**PLANNED UNIT DEVELOPMENT
AMENDED PRELIMINARY DEVELOPMENT PLAN
MCKITRICK PROPERTY/I-270 AND COFFMAN ROAD**

June 15, 1995
Revised: March 25, 1997
(Revisions in bold italics)

Planned Unit Development
Subarea 4, Single-Family
Killilea
PRELIMINARY DEVELOPMENT PLAN

HOUSE #4 As submitted, this example not acceptable

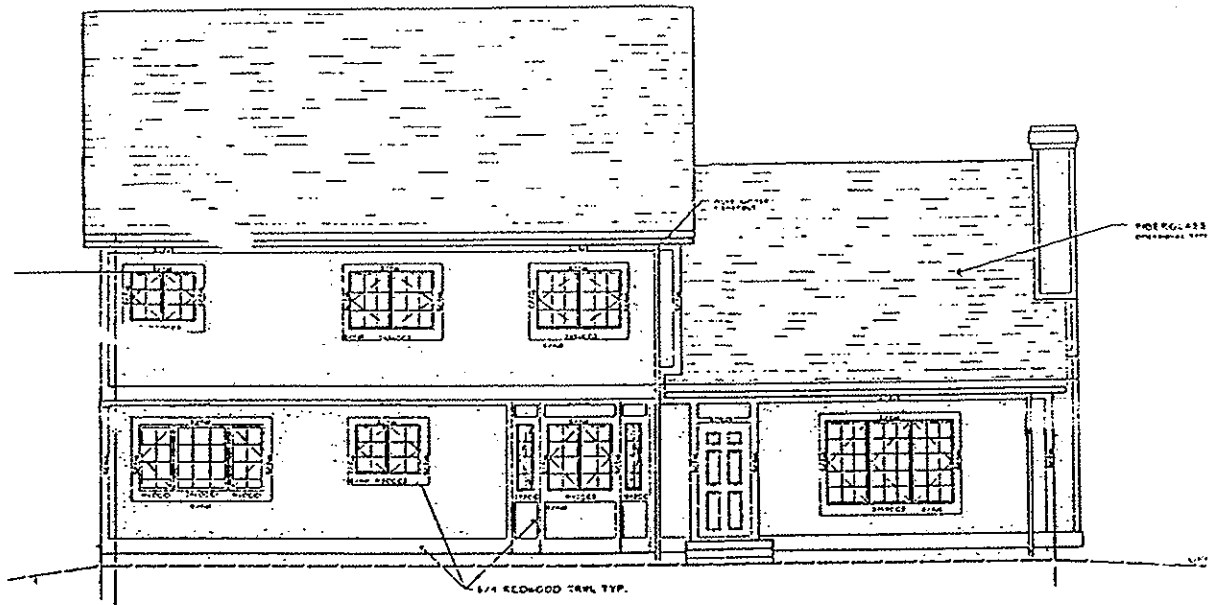
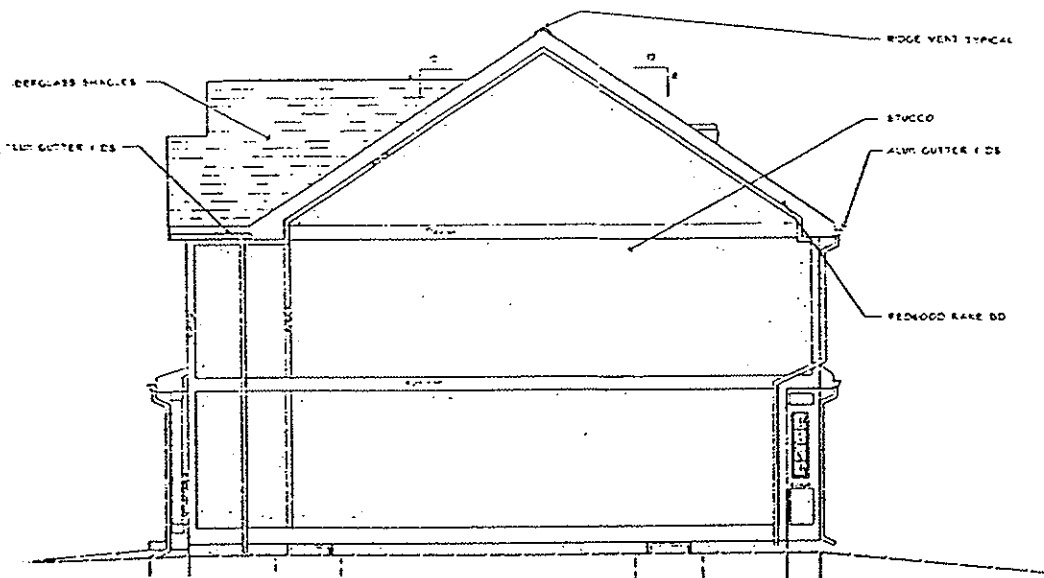
The following is recommended:

- Masonry exterior chimney, i.e., brick, stone, or stucco stone (same material as front elevation)
- Windows to match front elevation
